# HISTORIC LANDMARK COMMISSION Application for a Certificate of Appropriateness June 1, 2022 C14H-2011-0020; HR-2022-062618 Lindemann House 1100 E 8<sup>th</sup> Street

# PROPOSAL

Window replacement throughout. Convert a rear window into a door.

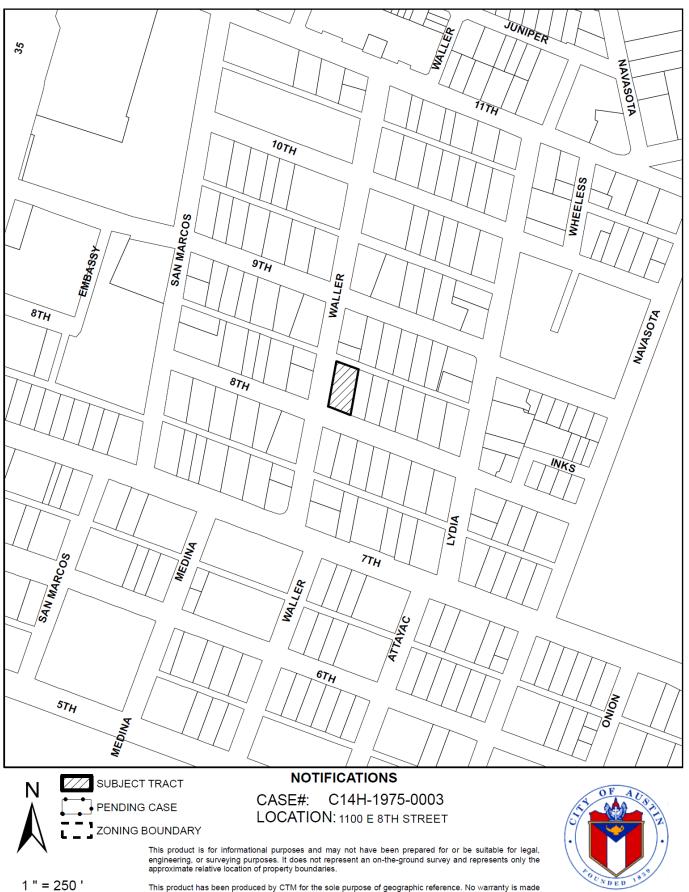
Standard 5.13 establishes requirements for historic landmarks. It states that window and door openings should not be enlarged, moved, or enclosed except as required by an addition. On the north elevation, a window will be replaced by a white pine door, altering the existing opening. However, the window that is being replaced is on the back of the house and will not be visible from the street.

Approve the application but encourage the applicant to repair, rather than replace, any original windows at front and sides of house or where visible from the street. Consider approval of rear window replacement with door. Should the Commission allow replacement, encourage the applicant to keep and store the existing window so that the alteration may be reversed in the future.
